Our ref. 73961B011
TE/NUPR/PD/DAN

Brussels, March 13th , 1984

As a representative of the belgian utilities to the Westinghouse Owners' Group , I have received a copy of your letter of November 15 , 1983 relating to the approach introduced in the Borselle reactor to cope with a SGTR accident.

C. Impact of application of the low pressurizer pressure-low pressurizer level coincidence trip in Westinghouse reactors

FIG. 4 : WATER LEVEL IN PRESSURIZER (LRCA/PR11)

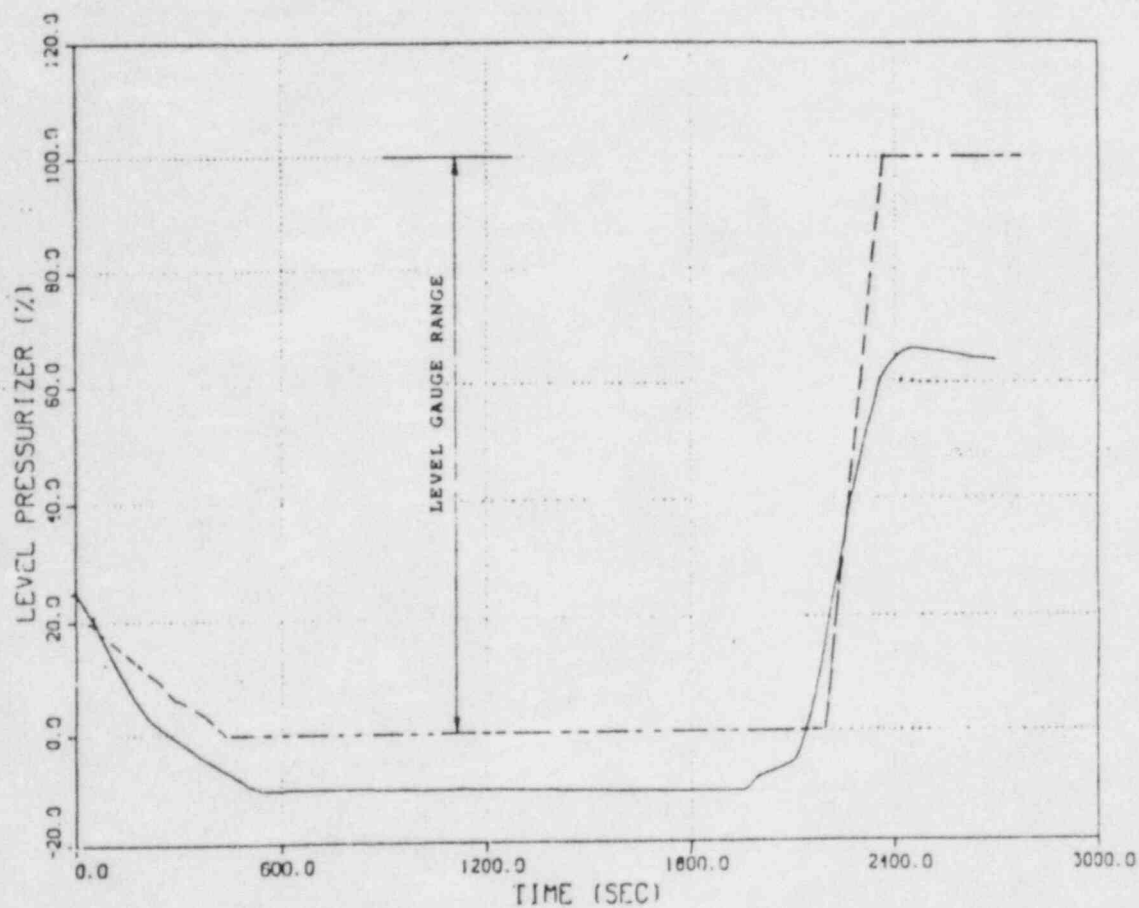
. In our plants , 'for many small break loca transients the application of a low pressurizer level - low pressurizer pressure coincidence trip will hardly change anything. Because of the smaller pressurizer size , the low pressurizer level setpoint will be reached before the low pressurizer pressure setpoint for SI generation is reached (cf events in Ginna , Doel , ref paper by E. STUBBE and H. MICHIELS presented at the Jackson Wyoming conference Sept 83 , fig. 4 - attached).

. However , many reactor transients have identified unreliable level readings (cf Doel) , because the level signal derived from a ΔP cell is calibrated only for nominal water conditions (densities) and cannot be used when the pressurizer conditions deviate from nominal conditions during a transient (e.g. by filling up with cold HPSI water combined with spray).
